EXHIBIT 3

Applicant(s): 360-116 GP 2607 File No. A-54681-1/JAS Serial
 No.: 07/956,453 Group Art Unit: 2607
 Filed: October 2, 1992 Date: September 24, 1993
 For: ACTIVE PROBE CARD

ELECTION OF SPECIES UNDER 37 CFR 1.146

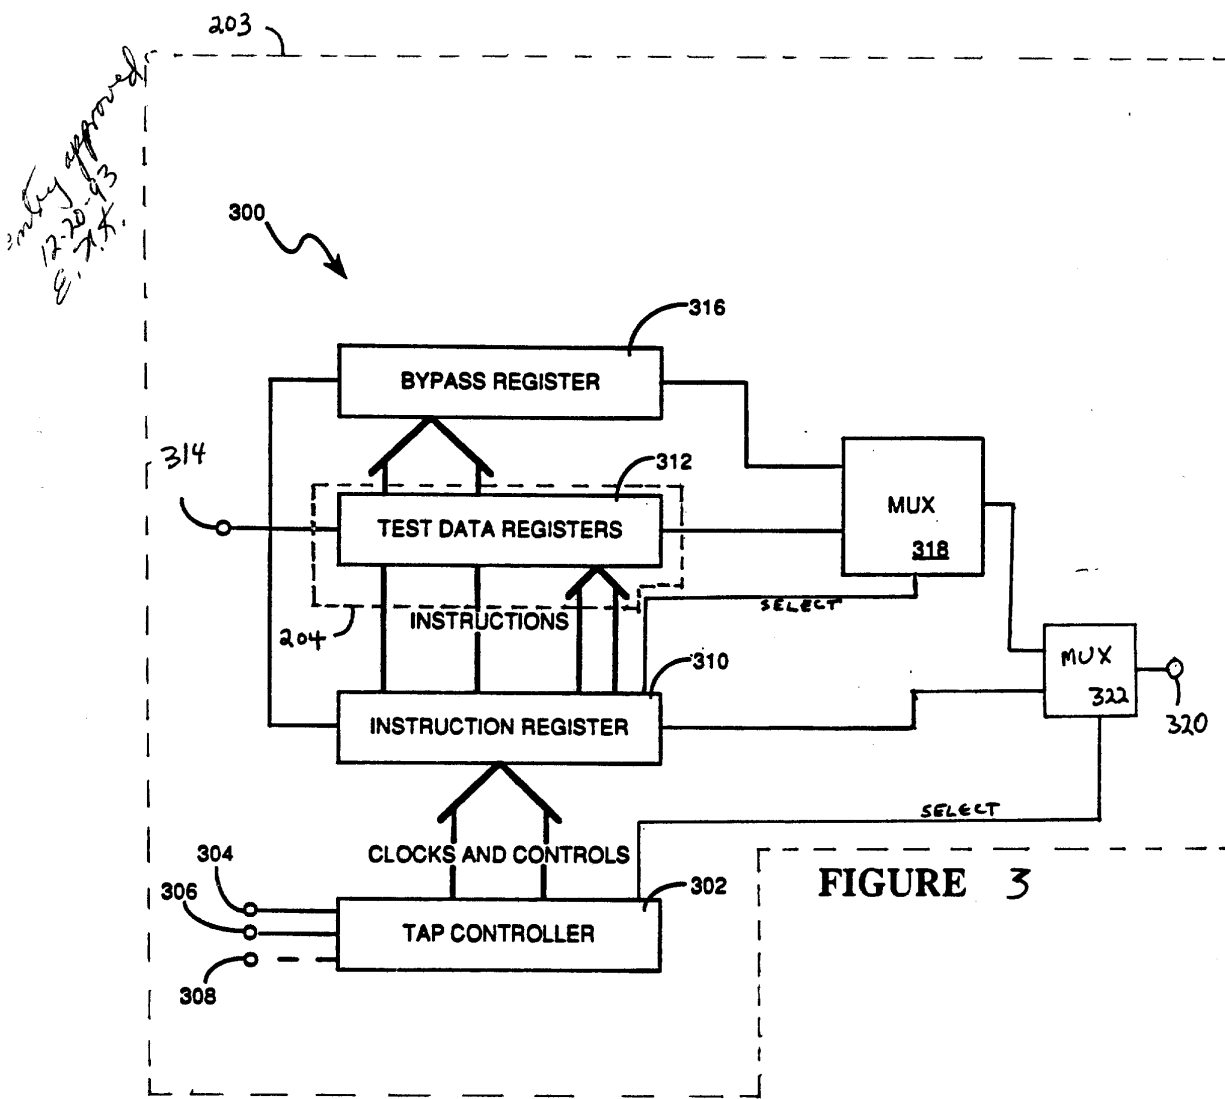
Referring to Figure 3, applicants have requested that a dotted line and associated reference designator 203 be added surrounding the entire JTAG circuitry 300, and a dotted line coupled with its associated reference designator 204 be added around the test data registers 312. Applicants point first to Figure 2 and the associated text in the specification at page 8, line 13 describing Figure 2 as depicting "the basic test circuitry arrangement mounted upon an active probe card 200 as called for in the IEEE standard 1149.1." As cited at page 3, line 3-13, IEEE 1149.1 defines the Standard Test Access Port and Boundary-Scan Architecture, also known as the JTAG standard. The JTAG standard utilizes control circuitry (not shown in this figure) and a number of registers formed into cells 204 housed in a typical integrated circuit (IC) 203 (Pg. 8, ln. 17-20).

Figure 3 is described as depicting the JTAG based test circuitry 300 housed in a single integrated circuit (Pg. 9, ln. 10). Applicants provided Figure 3 to further detail the basic test circuitry housed in a single integrated circuit. The reference numbering was originally selected with one reference number provided to refer to the IC's (203) housing the test circuitry, and a separate reference designator was assigned to

designate the actual test circuitry (300). Unfortunately, as pointed out by the Examiner, applicants attempt at clarity has only confused the issue. In addition to the functional language relationship that clearly exists in the specification, specific reference relating the figures exist, as found at page 9, line 22-24, wherein the test data registers 312 of Figure 3 are described as making up the boundary-scan cells 204 of Figure 2. As such, applicants respectfully submit that there exists sufficient support in the specification to justify the additions, since clearly the ICs 203 house the basic test circuitry 300.

FIGURE 4

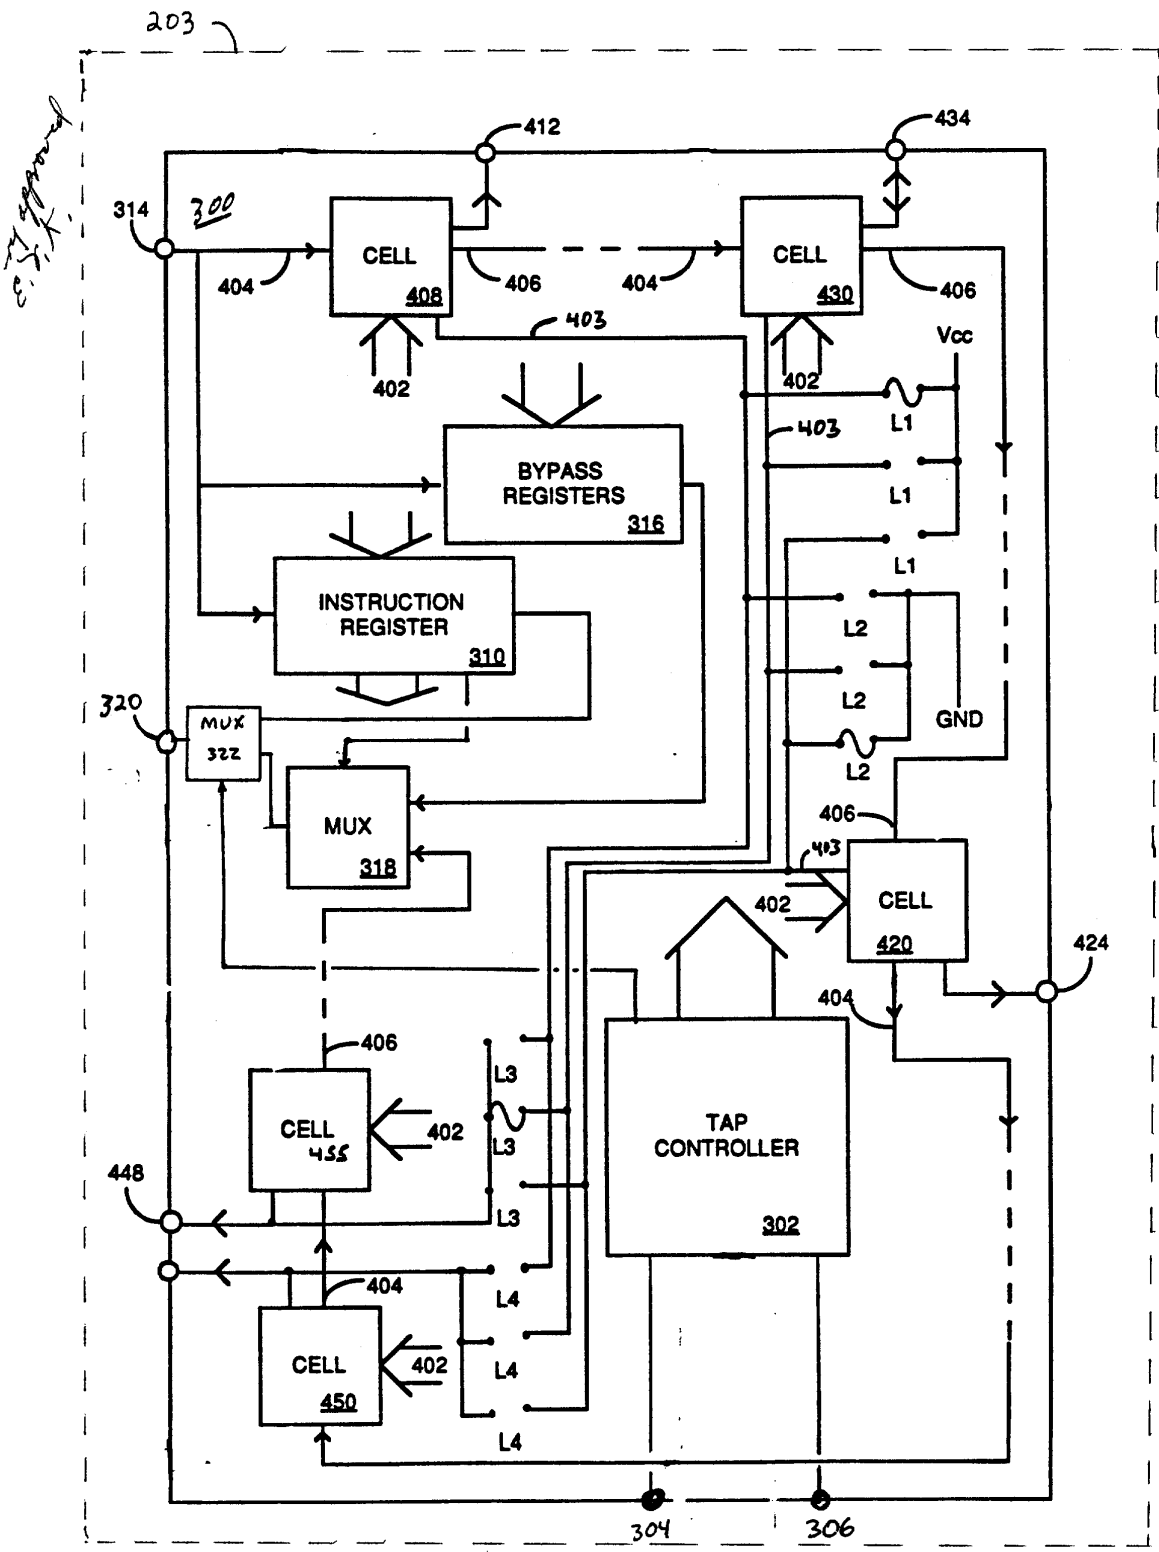
Referring to Figure 4, applicants have requested that a dashed line and accompanying reference designator 203 be added. Applicants had intended to provide a series of more detailed figures, Figure 4 being a more detailed depiction of the functional circuit of Figure 3 (Pg. 10, ln. 7-9). As such many of the same designators from Figure 3 are found on Figure 4 including the test circuitry 300 (now proposed to be 203 to be consistent with figure 3), the tap controller 302, the bypass register 316, instruction register 310 and muxes 318 and 322.

As such the clearly established relationship between Figure 3 and Figure 4 should provide adequate support to justify adding the enclosing box 203 representative of the IC housing.
